S E R V I C E N O T E

**EPM-441A Power Meter
(Product Number E4418A)**

In Line Fuse Holder Clips Defect.

DATE: March 1999

Figure 1

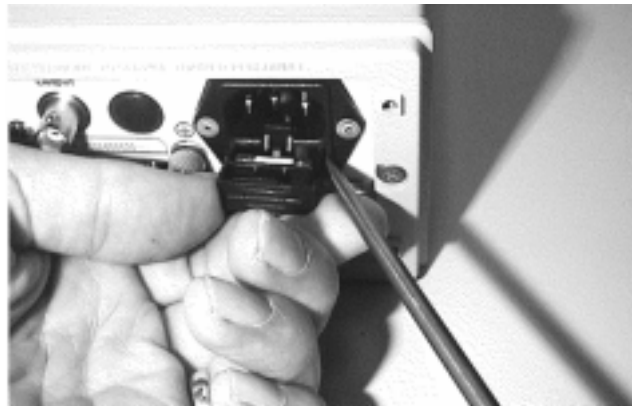
- 1) Remove the Fuse Box using a flat Blade screwdriver (See Figure 1)

Figure 4

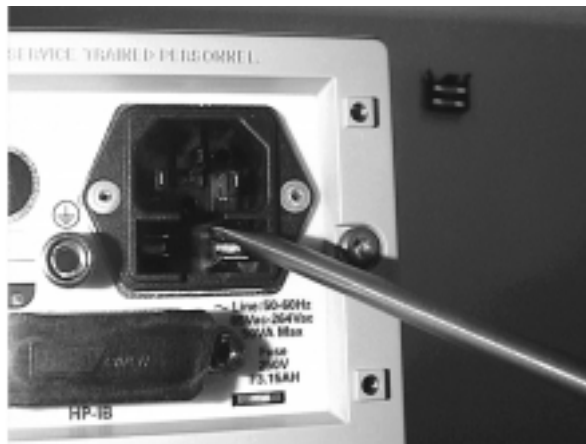
The true fault is that one of the fingers of the fuse holder (the right hand upper fuse clip as viewed from the rear) has been formed incorrectly thus providing an intermittent contact. This has been traced to units within a certain batch code. These fuse clips need to be repaired.

- 5) If there is any evidence of arcing then proceed to step 8.
- 6) If there is no evidence of arcing then bend the fuse clip into the correct position (i.e. level with the left hand clip) using a Flat Blade screw as shown in figure 4. Proceed to step 7.

Figure 5

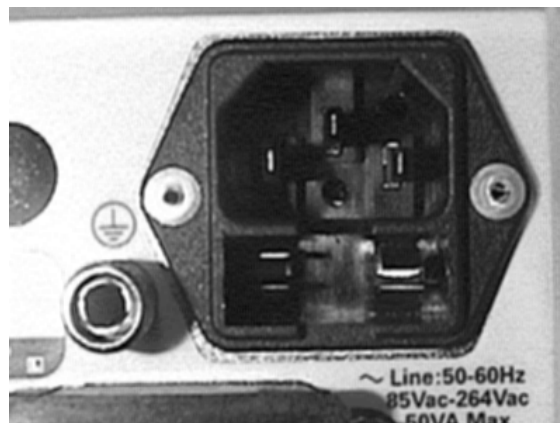
- 7) Ensure the fuse holder clip has not been bent too far (as per Figure 5).

If it is bent too far bend it to the correct position as per step 6 Proceed to step 9.
